# 2016 ANNUAL INSPECTION REPORT

## MILLTOWN DAM

NDI ID No. PA-00218

GF Project No. 060466.0102

**Photo No. 5**

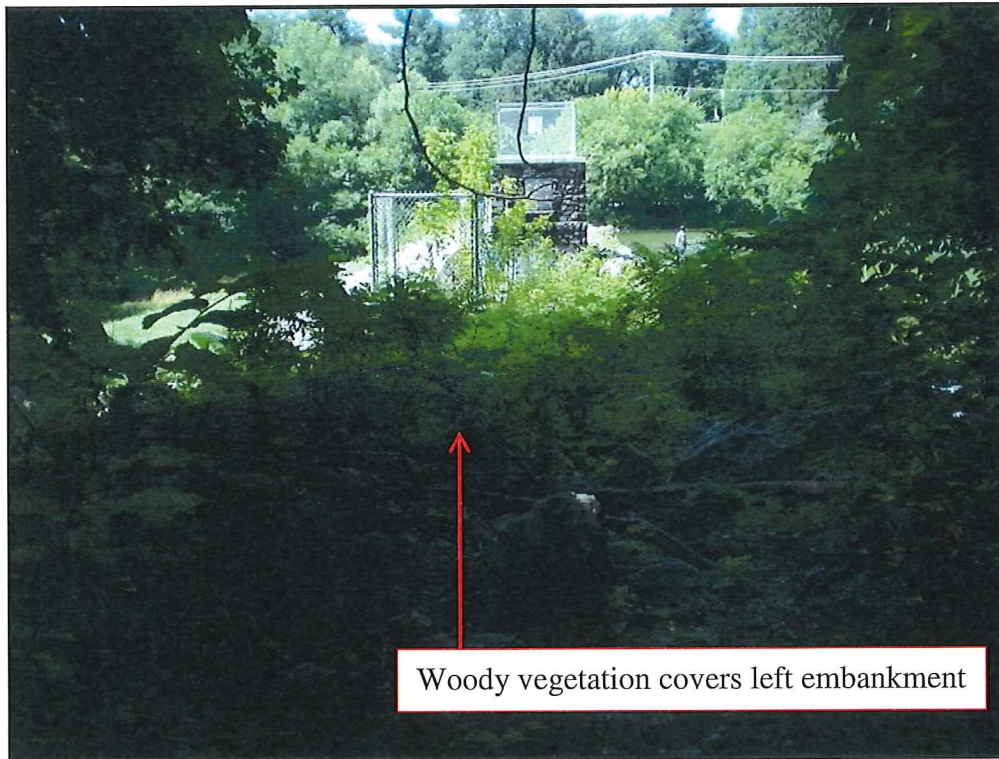
ITEM	CONDITION	COMMENTS	MONITOR	INVESTIGATE	REPAIR
<b>EMBANKMENT: CREST</b>					
1	Surface Cracking	None observed. Right embankment crest paved with aggregate. Left embankment crest armored with riprap (refer to Photos 1 & 6).	<input type="checkbox"/>	<input type="checkbox"/>	<input type="checkbox"/>
2	Sinkhole, Animal Burrow	None observed.	<input type="checkbox"/>	<input type="checkbox"/>	<input type="checkbox"/>
3	Low Area(s)	None observed. See note below.	<input type="checkbox"/>	<input type="checkbox"/>	<input type="checkbox"/>
4	Horizontal Alignment	No deficiencies observed.	<input type="checkbox"/>	<input type="checkbox"/>	<input type="checkbox"/>
5	Ruts and/or Puddles	None observed.	<input type="checkbox"/>	<input type="checkbox"/>	<input type="checkbox"/>
6	Vegetation Condition	Right embankment crest paved with aggregate (refer to Photo 1). Left embankment crest armored with riprap. Woody vegetation observed on left embankment crest (refer to Photo 6).	<input type="checkbox"/>	<input type="checkbox"/>	<input checked="" type="checkbox"/>

**Photo No. 13**

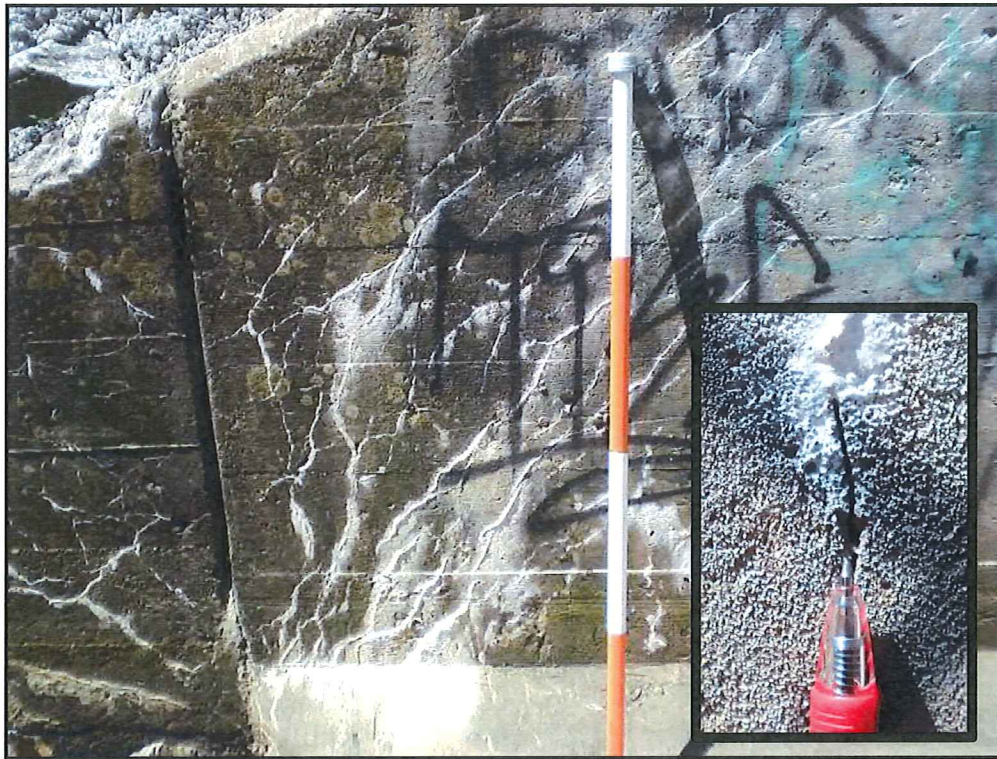
Item 50: Hairline cracking with efflorescence observed on the vertical portions of both the left and right spillway training walls (refer to Photos 14, 15, 19 & 20). Several spalls observed near downstream end of right spillway training wall (refer to Photo 16). **Recommend** monitoring concrete for changes in condition which may require additional repairs.  
**Recommend** repairing spalled concrete on right spillway training wall.

**Photo No. 28  
View of downstream face of exposed valve chamber. Note hairline cracking with efflorescence.**

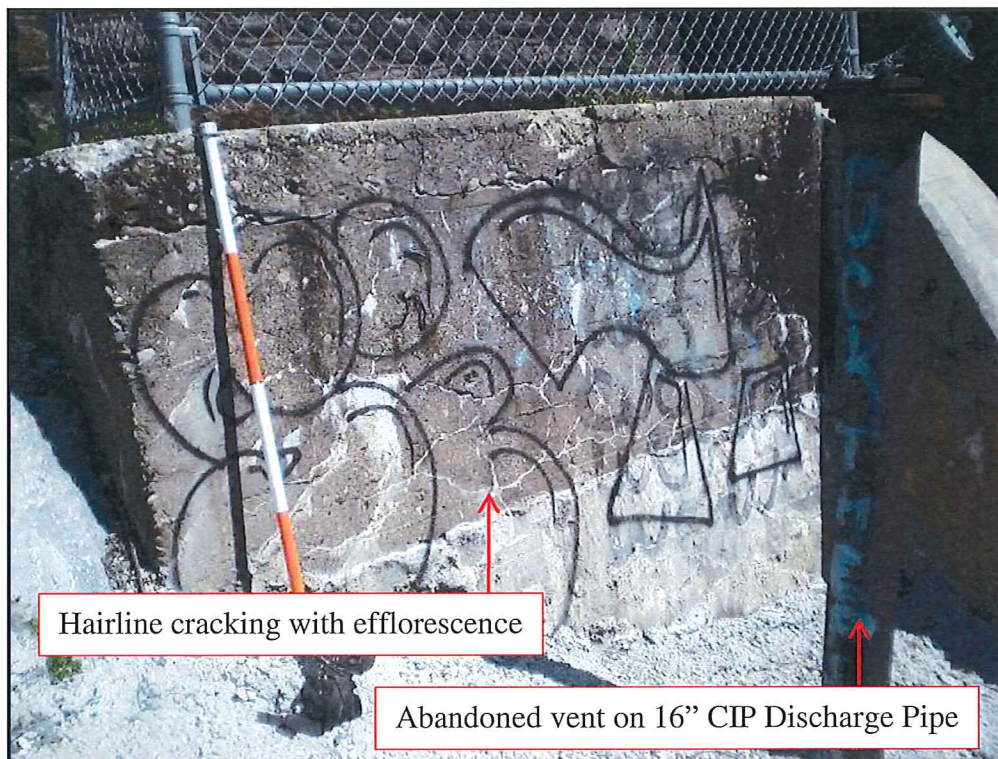
Item 59: Sluice gates were observed on the 16" and 24" CIPs entering and leaving the Valve House (four gates total) controlled by manually operated handwheels (refer to Photos 31, 32, 33 & 34). The upstream 16" and 24" sluice gates were operated at time of inspection. Downstream gates are inoperable with the 16" gate frozen in the closed position and the 24" gate frozen in the open position. Downstream gates are not required for the operation of the low level dewatering system. East Goshen Township reports that the downstream 16" CIP has been abandoned and plugged at an unknown location downstream of the dam. Valve House constructed of masonry with lockable door and observed to be in fair condition (refer to Photos 25, and 27 through 30). Hairline cracks with efflorescence observed on exposed exterior portions of the valve chamber (refer to Photos 28, 29 & 30). Dampness with efflorescence observed in the interior downstream left corner of the concrete valve chamber (refer to Photo 34). **Recommend** monitoring the condition of the concrete valve chamber for changes in condition which may warrant repairs.
